**SITE PLAN REVIEW COMMITTEE
MEETING AGENDA**

DATE: Monday, January 25, 2016
TIME: 7:00 – 8:25 p.m.
PLACE: 2100 Clarendon Boulevard, Ground Floor
Cherry/Dogwood Conference Rooms (Rooms 109/110)
Arlington, VA 22202

Item 1. 2000 Clarendon Boulevard (SP #441) 7:00pm–8:25pm
(RPC # 17-012-012 and -013)
Planning Commission and County Board meetings to be determined.
Peter Schulz (CPHD Staff)

Figure 1--Site

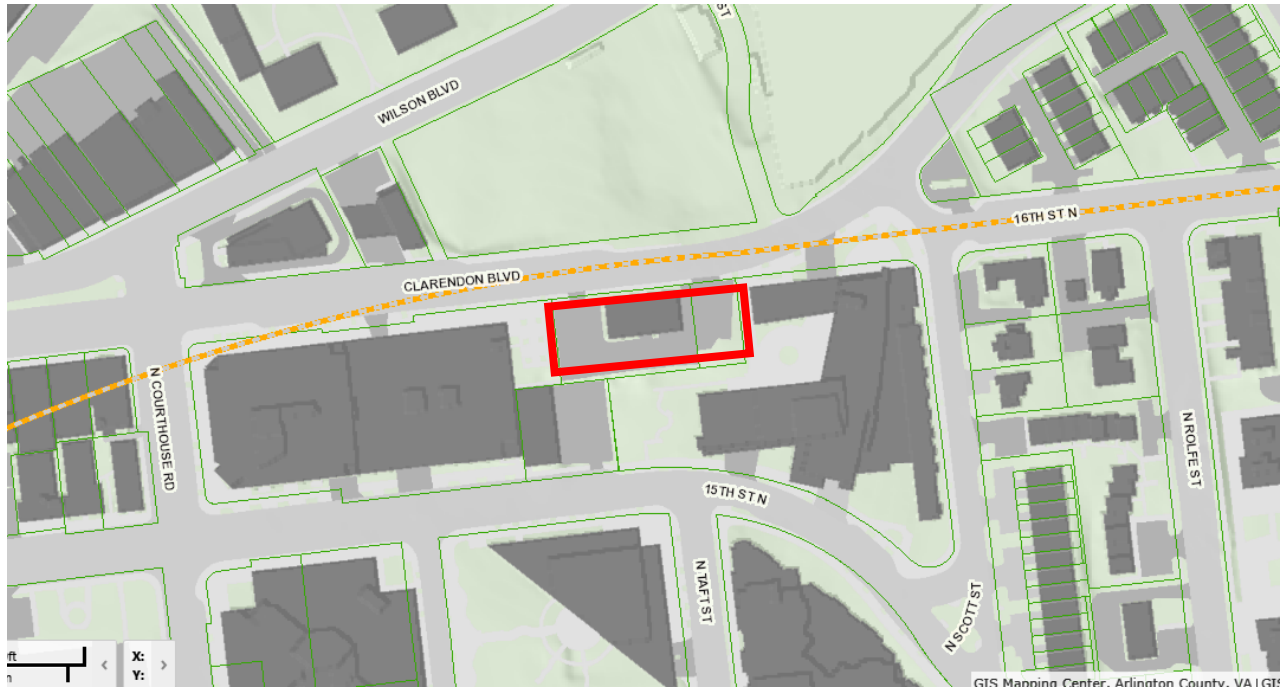
The 18,380 sq. ft. site is located at 2000 Clarendon Boulevard. The site is in the interior of a block roughly bounded by Clarendon Boulevard (north), N. Scott Street (east), 15th Street North (south), and N. Courthouse Road (west).
